HORSHAM ENTERPRISE PARK (LOVELLS SITE – PHASE 1 & 2), WIMBLEHURST ROAD, HORSHAM

Addendum Transport Assessment

ADDENDUM TRANSPORT ASSESSMENT

Document No:	183.0009/ATA/1	
Status:	Original	
	<i>Name</i>	<i>Date</i>
Prepared by:	Shannon Betteridge	June 2025
Checked by:	Mark Smith	June 2025
Approved by:	Mark Smith	June 2025

Figure 1: LTN 1/20 Appropriate protection from motor traffic on highways guidance

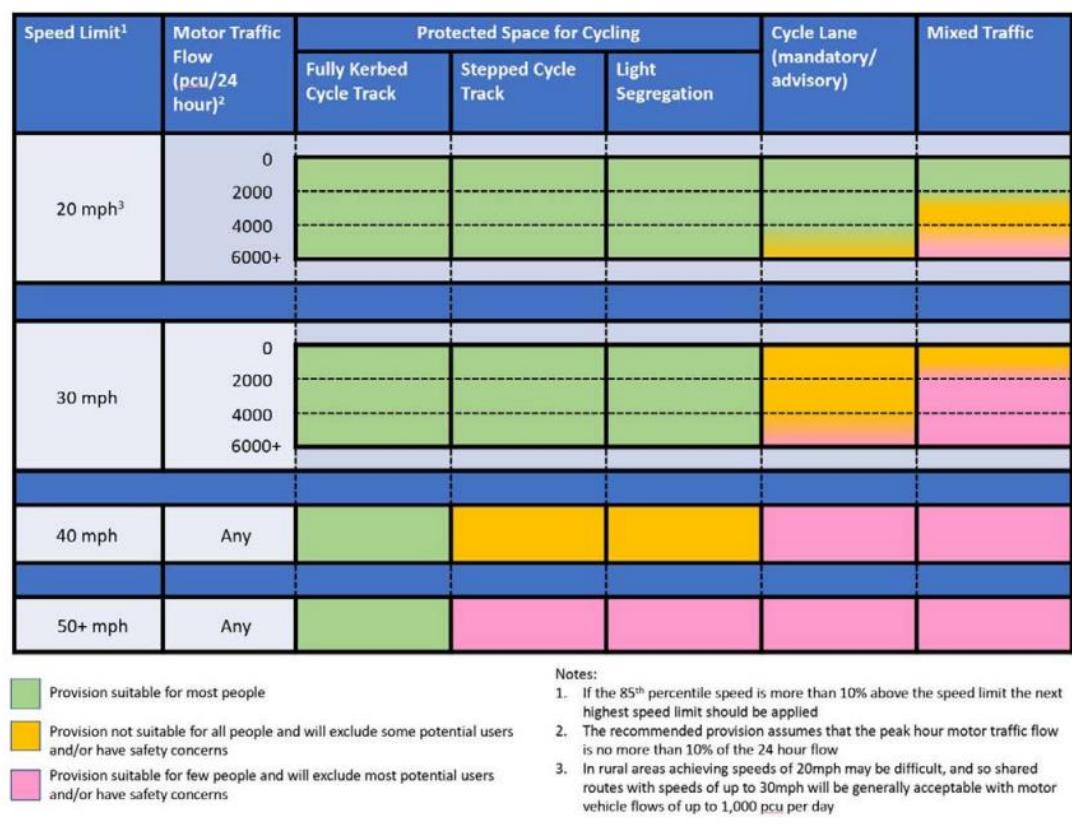
WSCC Highway Comment: With cycling, the assessment is also high-level. Point 3.21 of the TA makes reference to the gentle topography and wide carriageways within the local area making cycling attractive. There is though no mention of any consideration being given against LTN 1/20 or that the majority of carriageways in the local area are very well trafficked making on-carriageway cycling unfeasible for some users.

- 3.2 This has been noted and LTN 1/20 guidance has been reviewed. Although a new Automated Traffic Count (ATC) survey was not undertaken to support the proposed development, given that visibility was shown to the Wimblehurst Road/North Heath Lane/Parsonage Road roundabout to the north and to accord with 43mph to the south, it is considered that (due to the flows calculated during turning count surveys locally), Wimblehurst Road would fall within the 30mph, 6000+ Motor Traffic Flow, Mixed Traffic section of the table demonstrated in **Figure 1**.

- 3.3 With the above in mind, whilst it is acknowledged that some people could be deterred from cycling given the conditions along Wimblehurst Road, LTN1/20 is guidance, and some people will use the carriageway regardless.
- 3.4 A review of the collision data along Wimblehurst Road and routes into the town centre have also been undertaken to identify any particular road/route that could pose a concern for future cyclists. The data shown in **Figure 2** is from the Department for Transport Mapping Application for Visualising Road Injury Casualties (MAVRIC) and has been set for 1st January 2019 to the latest available date (31st December 2023) timeframe. The casualty type has been set to pedal cyclists.

Figure 3: Proposed Cycling Network (straight-line corridor) (Horsham LCWIP)

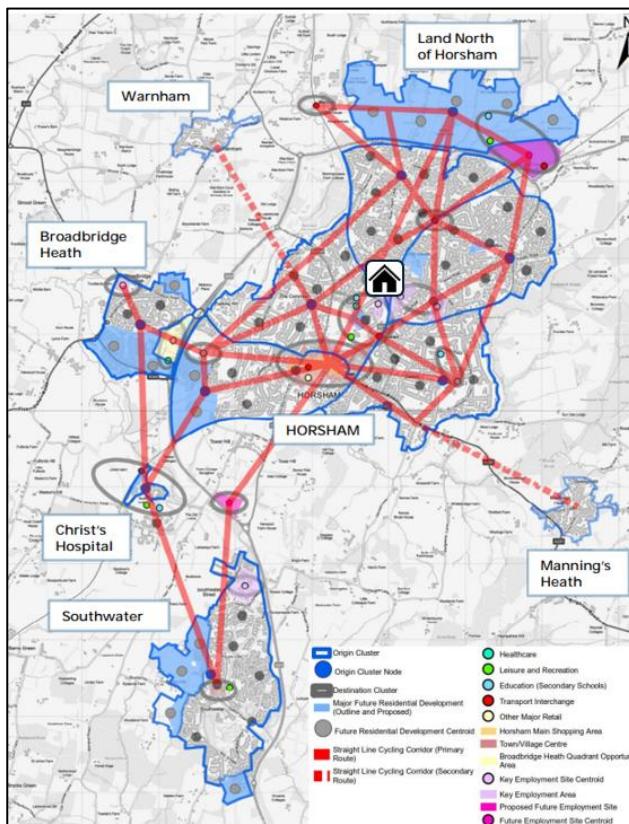
WSCC Highway Comment: Again with cycling, the Horsham LCWIP identifies routes to the immediate east (Kings Road/North Street) and west (along Wimblehurst Road/North Heath Lane). In the circumstances, the provision of a route from the development site into one of these more strategic cycling corridors seems appropriate and would only benefit future residents; this could form an obligation on the development. It's noted that the location of these LCWIP schemes is mentioned in the Travel Plan but not the TA.

3.7 To further improve the cycling infrastructure within Horsham, the Horsham LCWIP proposes a series of strategic cycle corridors to facilitate increased cycling in the local area. The proposed cycling corridors are outlined in **Figure 3**.

3.8 The location of the site in relation to the routes along Kings Road/North Street and particularly that along Wimblehurst Road/North Heath Lane would mean that future site users would benefit from these improvements.

3.9 Any CIL monies collected from the development could be used to implement the LCWIP schemes, but as aforementioned, the development could also fund advisory on carriageway markings along Wimblehurst Road, as it was observed that these are not currently provided.

Figure 4: Snip of Car Parking Tracking

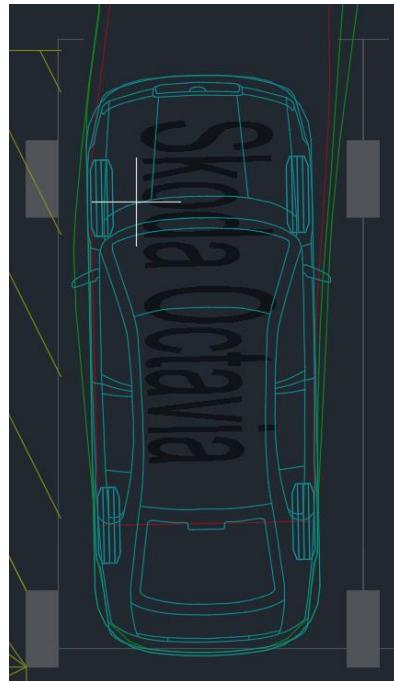
Stantec Comment: Basement Parking is also part of the parking mix (77 spaces). Whilst Basement Parking is appropriate, the constrained nature of a basement should be fully considered. If spaces are too tight to ensure regular use, even if the spaces are theoretically of sufficient size, commentary should be made that the parking provision on the site is robust to ensure no overflow into remainder of site or onto the external highway network. The 77 spaces is approximately one-third of the total parking.

5.5 The car parking spaces provided within the basement measure 2.4m x 4.8m, with 6m aisle widths provided where appropriate, which ensures that the space dimensions accord with the standards.

5.6 Across the basement, there are spaces which have structural elements such as pillars adjacent to them, and in most instances, there is additional width circa 100 – 200mm on at least one side of the space prior to the pillar. It is acknowledged that some spaces do have pillars on the boundaries of the spaces which border other spaces and as such, the width of the space is restricted a little. However, as shown on the tracking drawing submitted with the TA, where this does occur, the available width is still greater than that of a ‘typical’ car (see **Figure 4**).

5.7 Therefore, given that the site is ‘overproviding’ on spaces in relation to the standards, and that the car parking tracking within the basement shows the spaces are suitable, it is not considered that the basement is providing a constrained nature.

OFF-SITE IMPROVEMENT WORKS AT WIMBLEHURST RD/RICHMOND ROAD JUNCTION

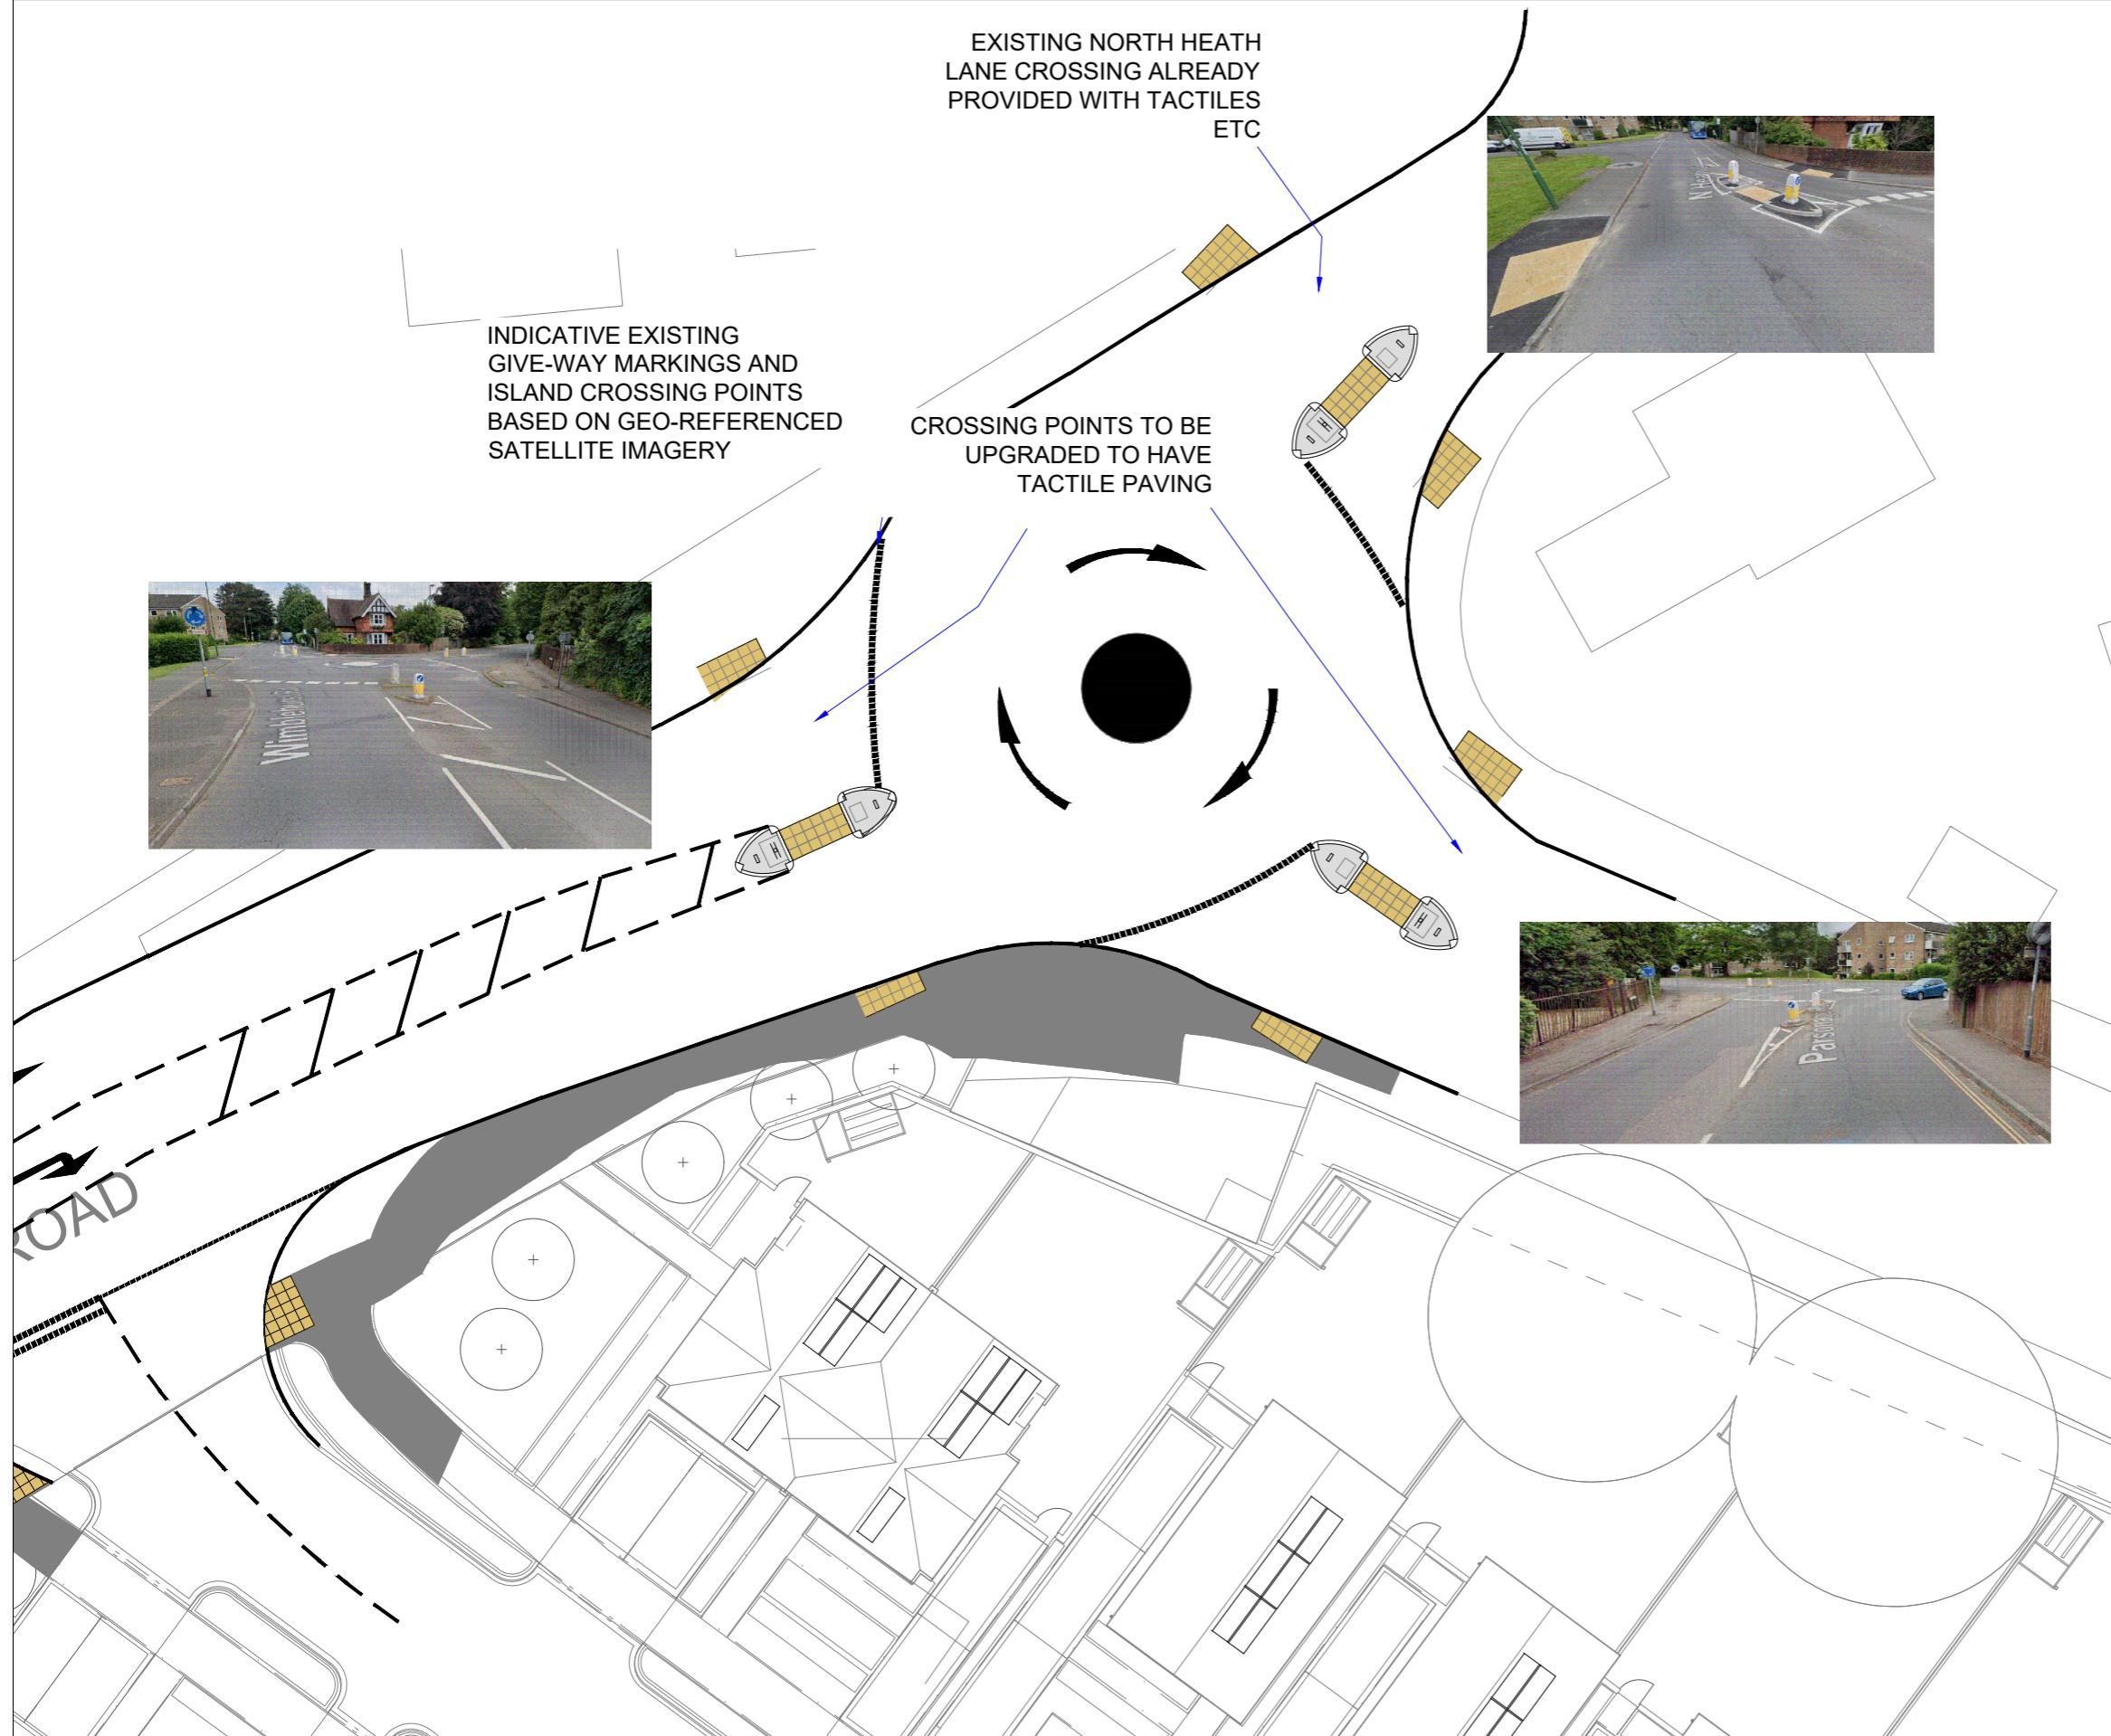
WSCC Highway Comment: A 'Copenhagen' crossing is also shown at the Wimblehurst Road/Richmond Road junction. Some of the concerns stated above for the site access junction would be applicable for this too. The design of both 'Copenhagen' crossings should be reviewed.

2.4 It was proposed in the original TA that the Wimblehurst Road/Richmond Road junction would also comprise a 'Copenhagen Crossing' to maintain a 'pedestrian priority'. However, given the comments raised by WSCC in relation to the site access and that the design has been revised to remove the crossing, proposing one at the Wimblehurst Road/Richmond Road junction would mean that it is provided in isolation and would likely lead to confusion for pedestrians and drivers alike. With consideration to the comments made for the site access, and specifically that vehicles would obstruct Wimblehurst Road whilst awaiting pedestrians to cross, this 'Copenhagen Crossing' is also now proposed to be removed. The junction would however still be improved with the addition of tactile paving to encourage mobility and visually impaired users to cross the junction.
